G14-D31

A PROPOSED PLAN FOR A SURFACE DRAINAGE INLET AT MATTHEW AVENUE, N.W. ALBUQUERQUE, NEW MEXICO

A PROPOSED PLAN FOR A SURFACE DRAINAGE INLET AT MATTHEW AVENUE, N.W. ALBUQUERQUE, NEW MEXICO

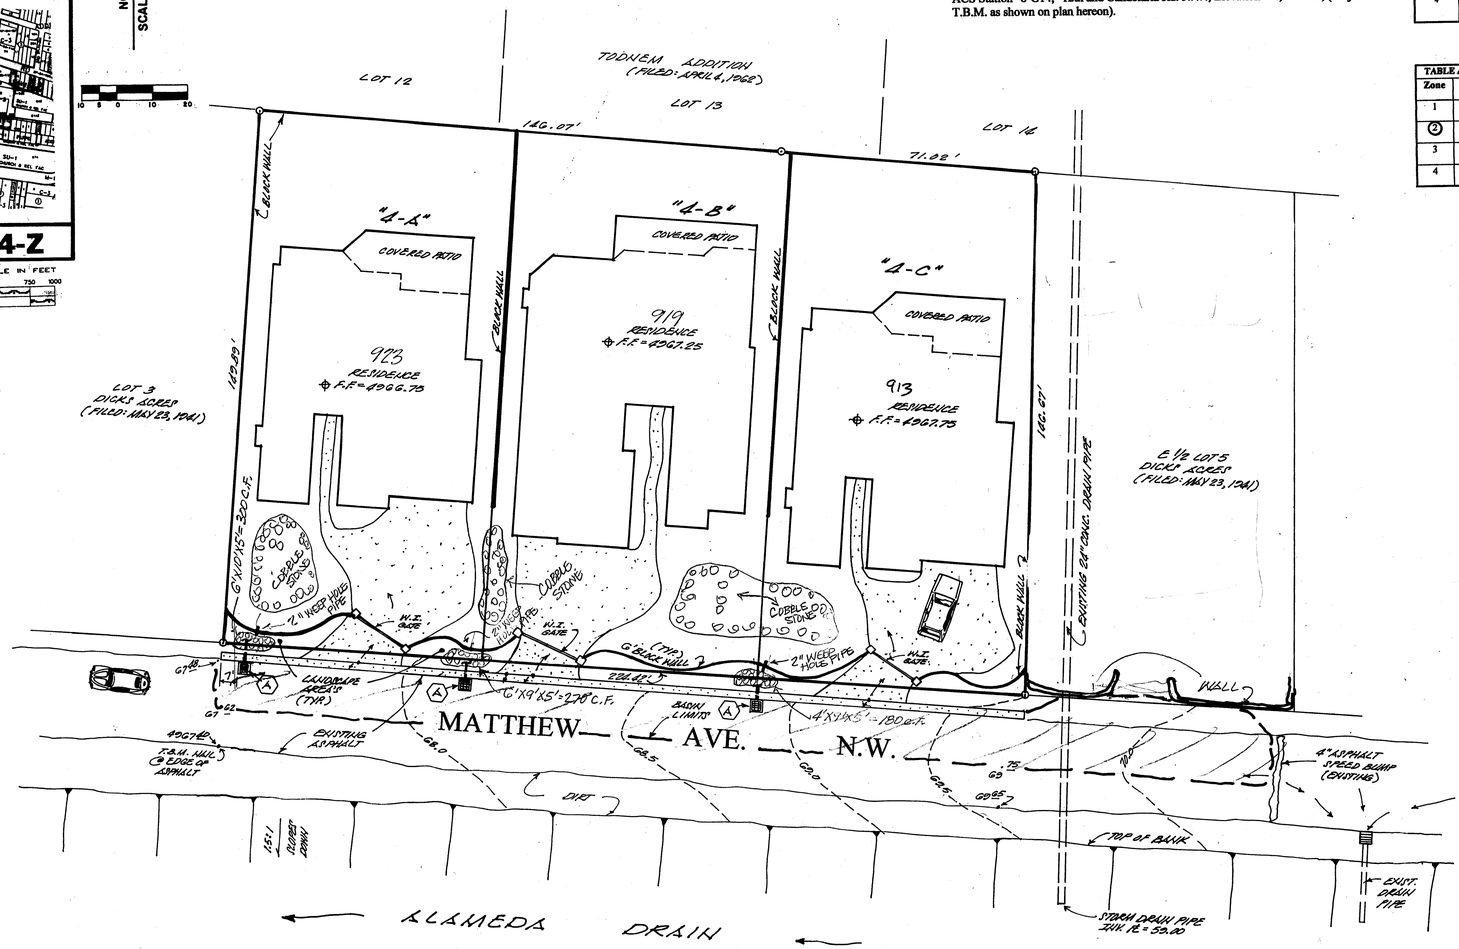
The purpose of this plan is to provide a storm inlet that will accept the existing developed street flows of the North 1/2 of Matthew Avenue N.W. and the associated drainage basin so that said flows will not adversely affect downstream properties; ~~these existing flows will be to directed through the proposed storm inlet into the Alameda Drain.~~

SITE AREA: ~~0.38~~ 0.13 ACRE TOTAL, ZONE: TWO (2)

~~"Qp" = 0.97 + 0.56 = 1.52 cfs TOTAL~~
